Appl. No. 10/731,496
Amdt. dated August 22, 2006
Reply to Office action of May 23, 2006

AMENDMENT TO THE DRAWINGS

Annotated Drawing Sheet

Fig. 2

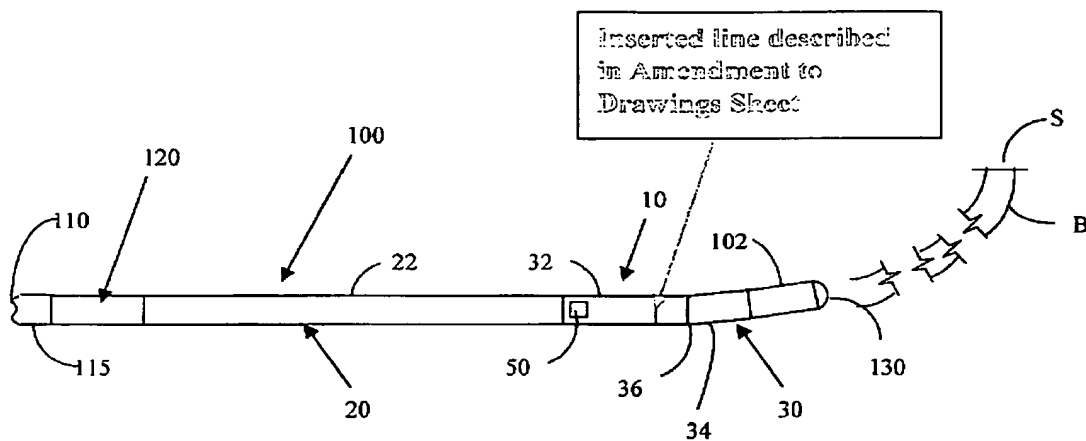
- Fig 2
 - Line was missing in drawing adjacent to Item 36. Line has been inserted so as to
 - clearly identify the division between Items 32 and 34
- Fig 3.
 - Line as missing in drawing adjacent to Item 36. Line has been inserted so as to
 - clearly identify the division between Items 32 and 34
- Fig 4.
 - Numerical call out for Item 24 was moved to provide clarity
 - Item 32 was identifying the wrong item and has been corrected to illustrate the appropriate component
